Submit 1 Copy To Appropriate District	State of New Me		Form C-103			
Office <u>District I</u> – (575) 393-6161	Energy, Minerals and Natural Resources		Revised July 18, 2013			
1625 N. French Dr., Hobbs, NM 88240 District II – (575) 748-1283	ARTESIA DISTRUCT		WELL API NO. <b>30-015-27338</b>			
811 S. First St., Artesia, NM 88210	OIL CONSERVATION		5. Indicate Type			
<u>District III</u> - (505) 334-6178 1000 Rio Brazos Rd., Aztec, NM 87410	1220 South St. Fra	ncis Dr.	STATE			
<u>District IV</u> – (505) 476-3460	Santa Fe, NM 8	7505	6. State Oil & Ga			
1220 S. St. Francis Dr., Santa Fe, NM 87505	. · · · · · · · · · · · · · · · · · · ·					
	ICES AND REPORTS ON WELLS	5	7. Lease Name o	or Unit Agreement Name		
(DO NOT USE THIS FORM FOR PROPOSALS TO DRILL OR TO DEEPEN OR PLUG BACK TO A						
DIFFERENT RESERVOIR. USE "APPLI PROPOSALS.)	ICATION FOR PERMIT" (FORM C-101) F	OR SUCH	Conti	inental A State

1. Type of Well: Oil Well				8. Well Number		
				15		
-	Name of Operator			9. OGRID Number		
EOG M Resources Inc. 3. Address of Operator			15445 10. Pool name or Wildcat			
105 South Fourth St, Artesia, NM 88210			Turkey Track 7 Rvrs Qn GB SA

TD @ 2,404' PBTD @ 2,391'

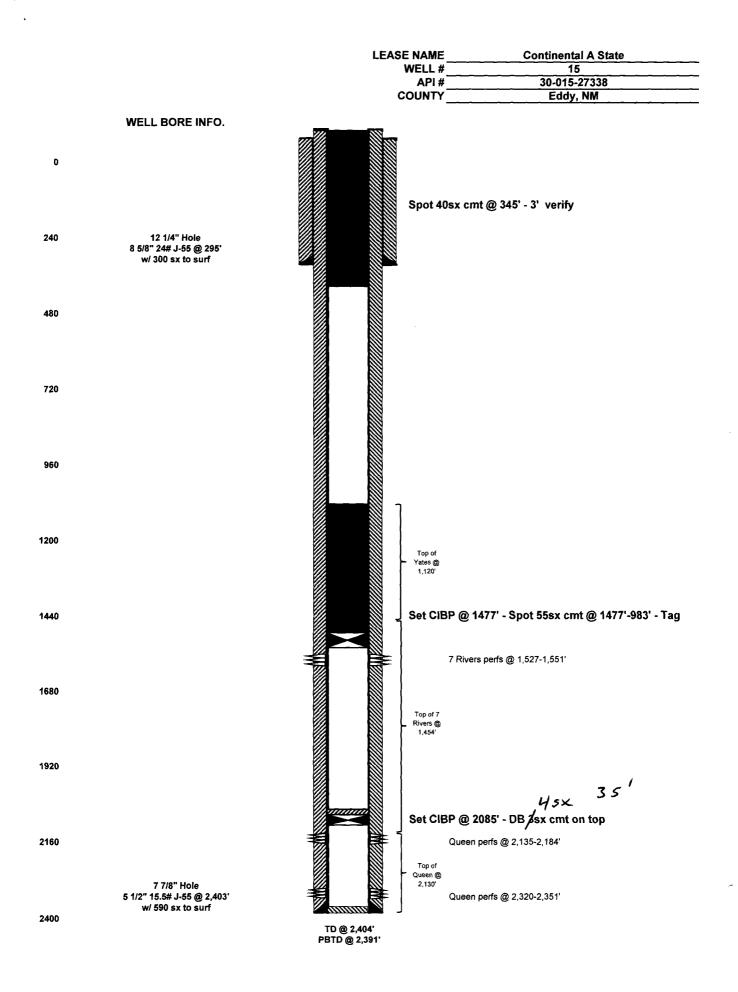
2. Set $5\frac{1}{2}$ " CIBP @ 2,085' – dumpbail 3sx cmt on top to 2,065' $(-3)$ (-3) (-3) (-3) (-3) (-3) (-3) (-3) (-3)						
4. Spot 40sx cmt @ $345^2 - 3^2$ Per $4 + S_0 = 2$

1. MIRU. ND WH, NU BOP 2. Set $5\frac{1}{2}$ " CIBP @ 2,085' - dumpbail 3sx cmt on top to 2,065' $\int test C_{59}$ B $5n t 9^{29}$ 3. Set $5\frac{1}{2}$ " CIBP @ 1,477'. Circ well w/ MLF. Cap BP w/ 55 sxs @ 1,477' - 983'. WOC-Tag 4. Spot 40sx cmt @ $345' - 3'$ $Perf + S_9 =$ 5. Verify cmt @ surface. Top off if necessary. RDMO. Cut off WH & anchors & install DH marker.

-					
A closed loop system will be used for all fluids from this wellbore and disposed of required by OCD Rule 19.15.17						
<b></b>	<u> </u>	<b></b>				
Spud Date:	Rig Release D	ate:				
1 hours		L				
The ATTAche	1 COAS	Must b	e Plusser	1 64 3-5-19
